**DETERMINED
PLAN**

GROUND FLOOR WALL VERTICAL SECTION
(FACING SOUTH-WEST).
PROPOSAL

ALTERATIONS: The Woodlands, Boston Road,
Gosberton, Spalding. PE11 4NU

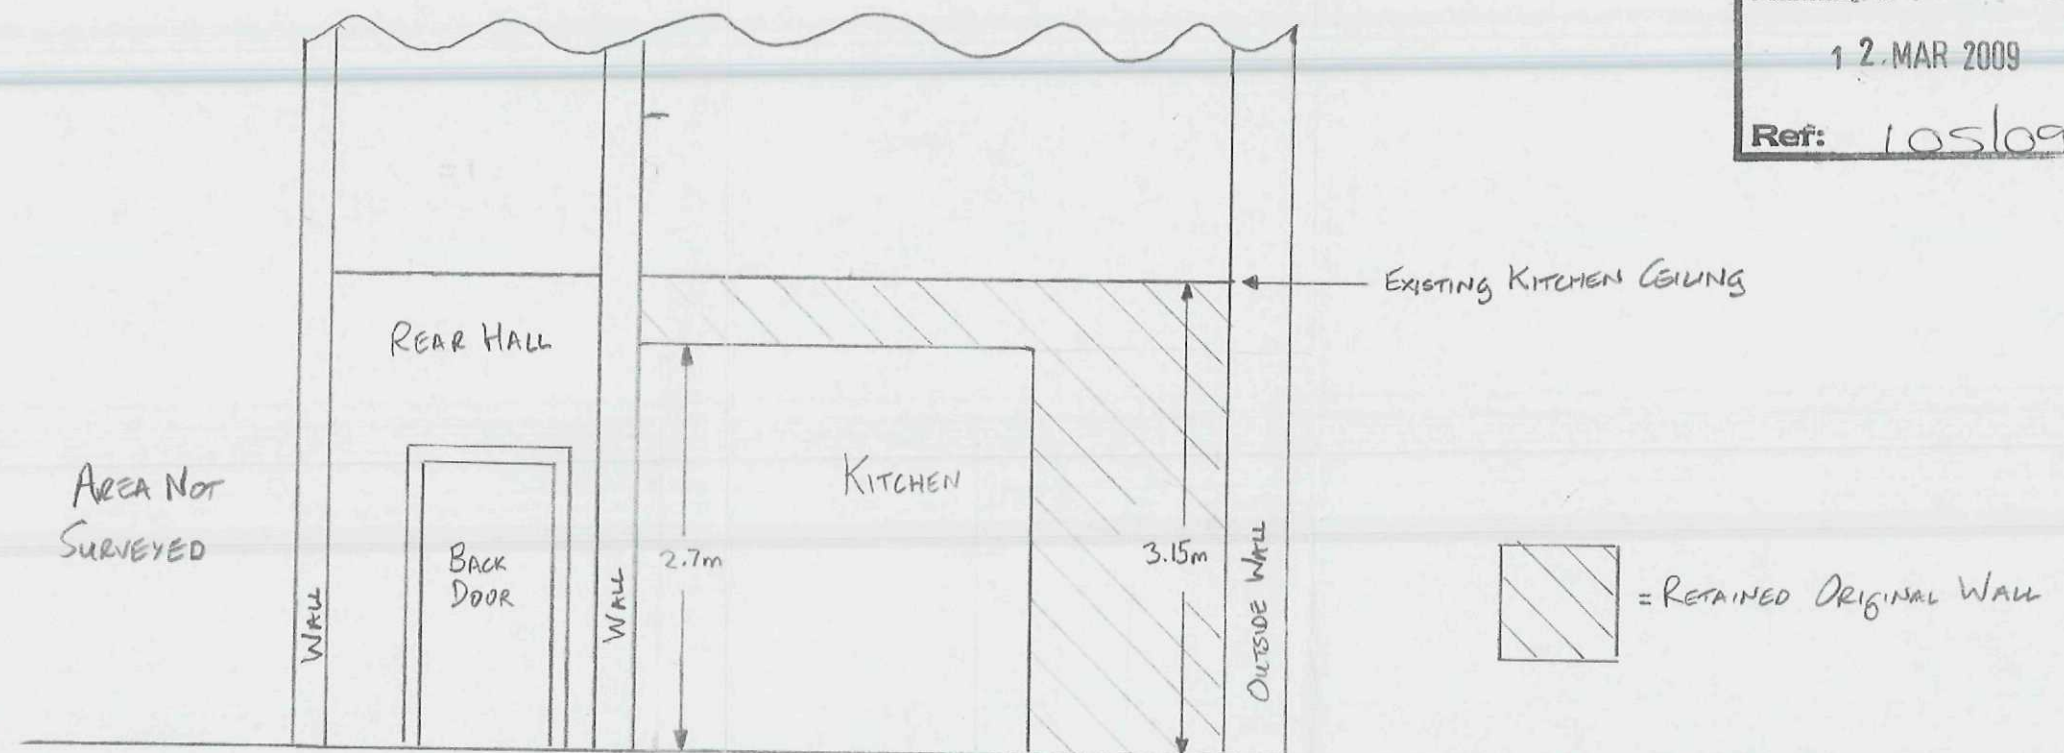
Concrete pad
foundation
possibly?
or metal frame
and open
and would need
RST 'goalpost' - as
minimum -
71 RST. x 2
